From: <eddie.grant@exeloncorp.com>
To: <jps1@nrc.gov>, <nvg@nrc.gov>
Date: 1/24/05 9:46AM
Subject: EP ETE RAI Responses to Letter No. 12

Early Site Permit (ESP) Application for the Clinton ESP Site
Docket No. 52-007

Subject: Response to Request for Additional Information Letter No. 12

Re: Letter, U.S. Nuclear Regulatory Commission (N. V. Gilles) to Exelon
Generation Company, LLC, (M. Kray), dated December 9, 2004, Request
for Additional Information (RAI) Letter No. 12 – Exelon Early Site Permit
(ESP) Application for the Clinton ESP Site (TAC No. MC1122)

Figure C-1. Predicted Rate of Vehicles Leaving the EPZ for Winter Day Adverse Weather

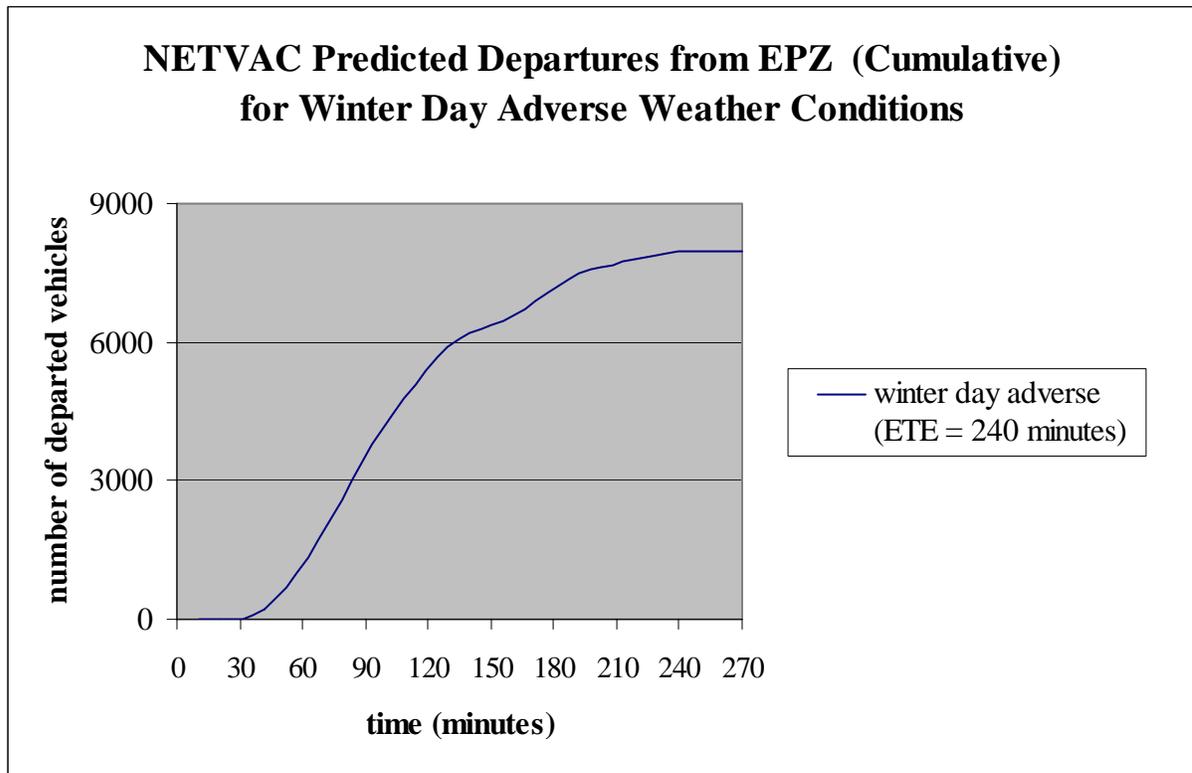
v) Since the additive reporting format for time estimates when probability distributions are used is not included in the 1993 ETE Study, provide the percentage of the population as a function of time.

A graph displaying the number of vehicles evacuating as a function of time for the Winter Day Adverse Weather scenario is provided as Figure C-1 in Attachment C.

**Figure 2.3-1
Evacuation Routes to Registration
and Congregate Care Shelters**

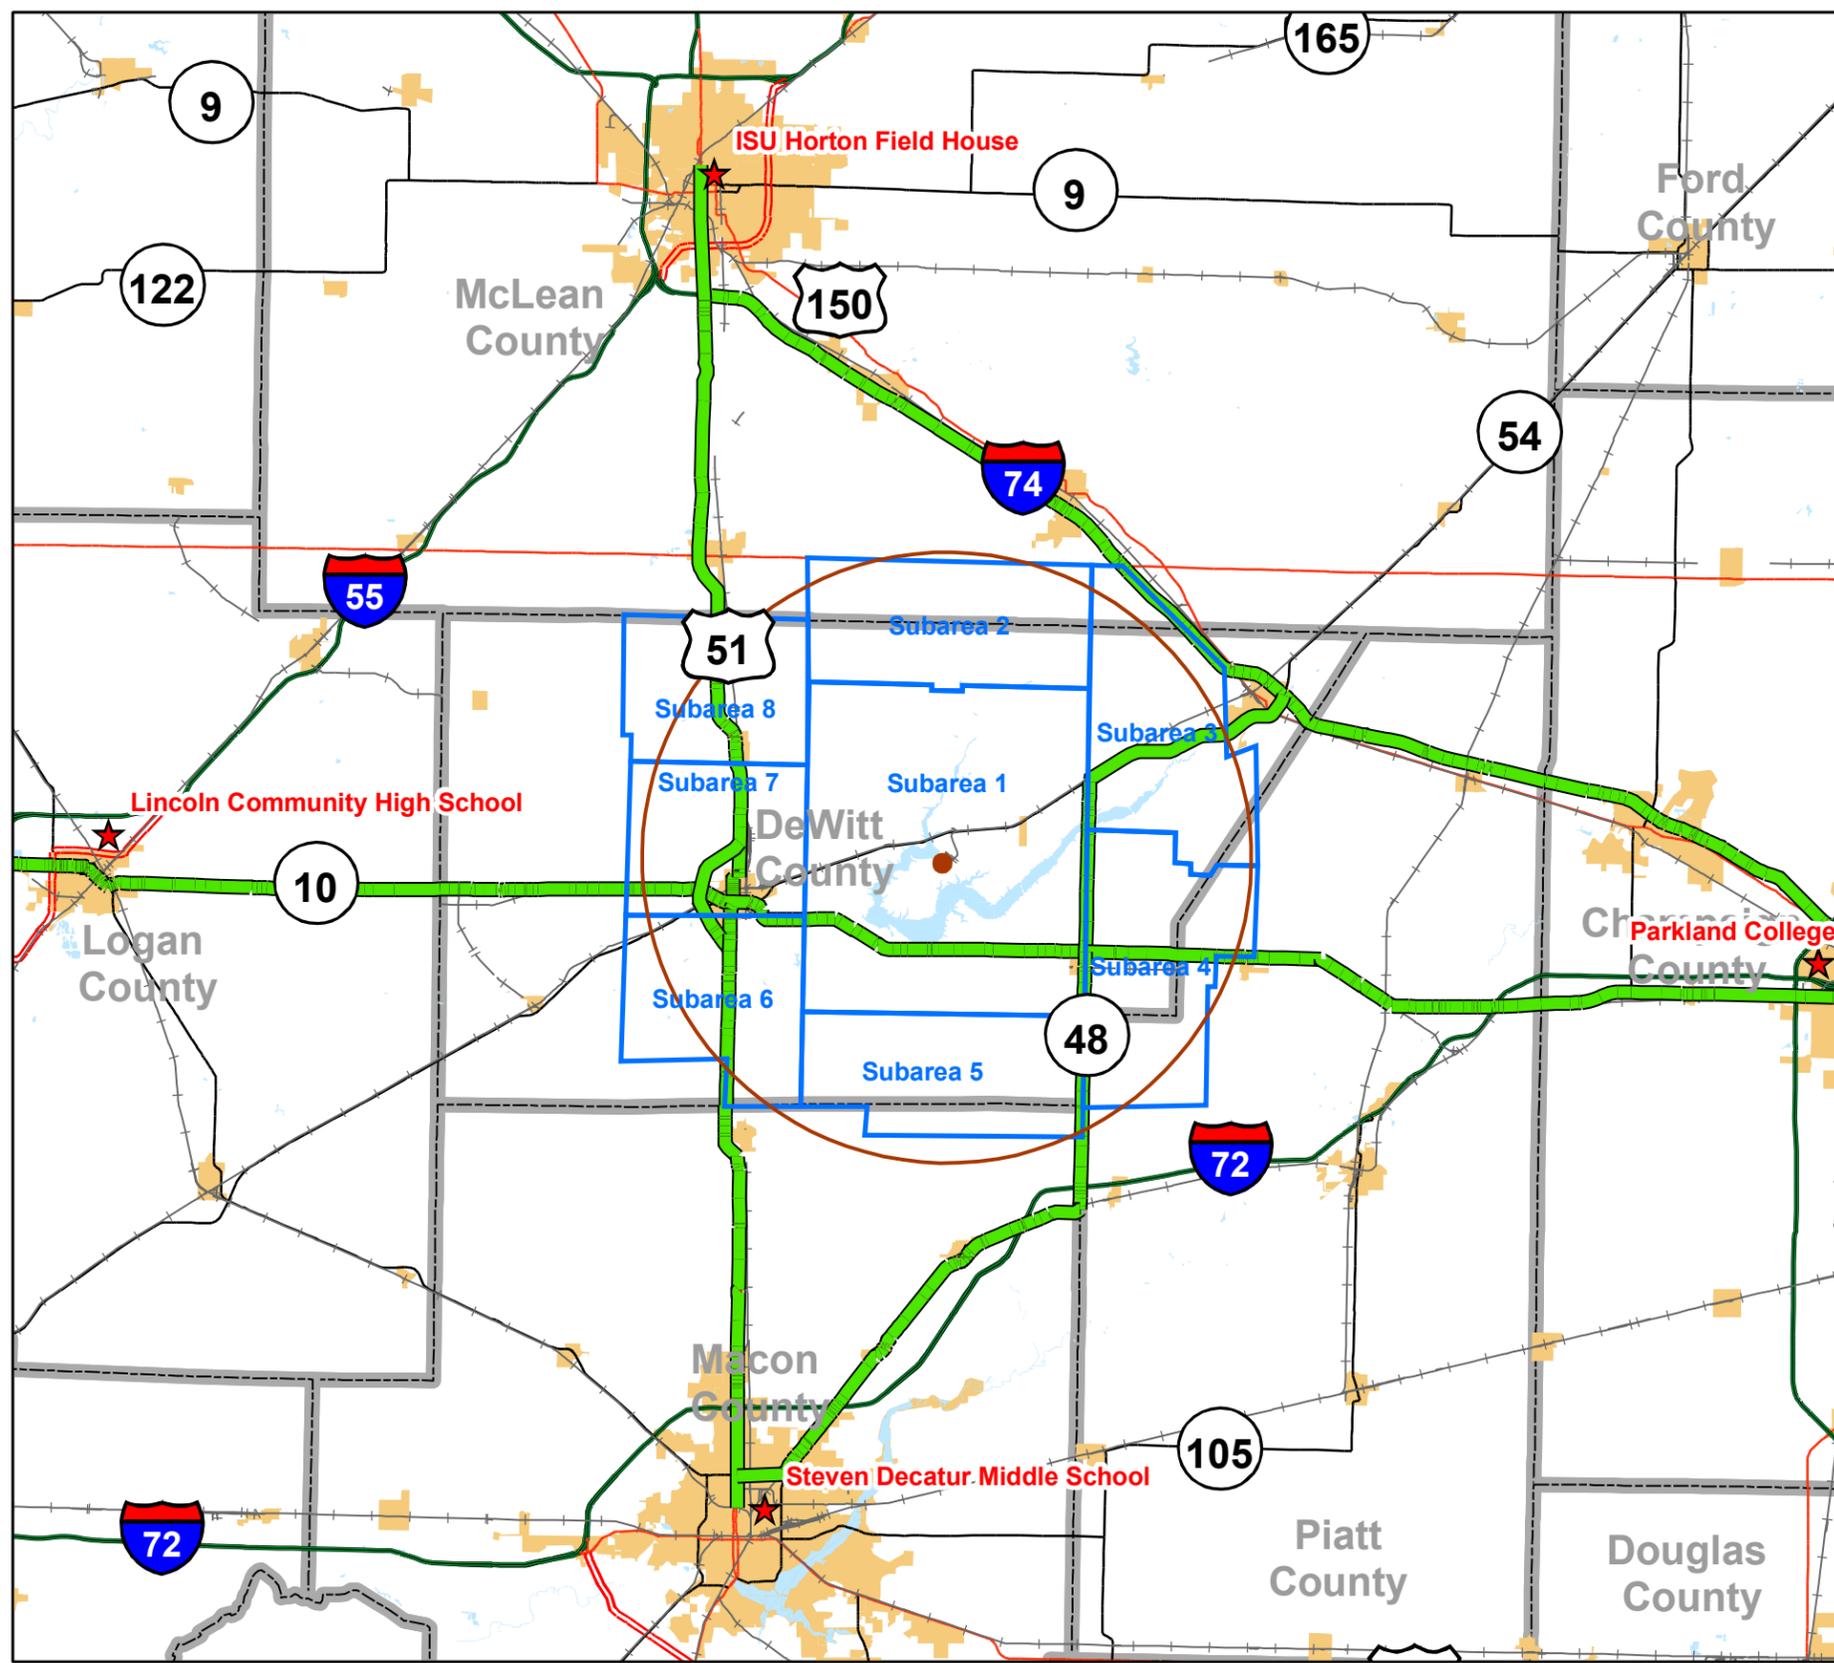
k) Regarding Section 1.3, "Reception Centers," in the 1993 ETE Study, Figure 2.3-1, "Evacuation Routes and Congregate Care Centers," in the Emergency Plan for the ESP application, and Map C, "Clinton-Shelter and Evacuation Map," in *The Illinois Plan for Radiological Accidents*, Volume VIII, identify which of these items correctly specifies the location of the Registration and Congregate Care Centers.

Therefore Figure 2.3-1 of the EGC ESP Emergency Plan will be revised to include the Lincoln Community High School as the registration and congregate care shelter for the city of Lincoln (West of EGC ESP Site).

The EGC ESP Emergency Plan will be revised to reflect the terminology used in IPRA Vol. VIII. For example, *Registration and Congregate Care Centers*, will be revised to *Registration and Congregate Care Shelters* in Section 2.3.1, in the title of Figure 2.3-1, and in Section 10.1.8.1.

Figure 2.3-1 of the EGC ESP Emergency Plan will be revised to include the Lincoln Community High School as the registration and congregate care shelter for the city of Lincoln (West of EGC ESP Site).
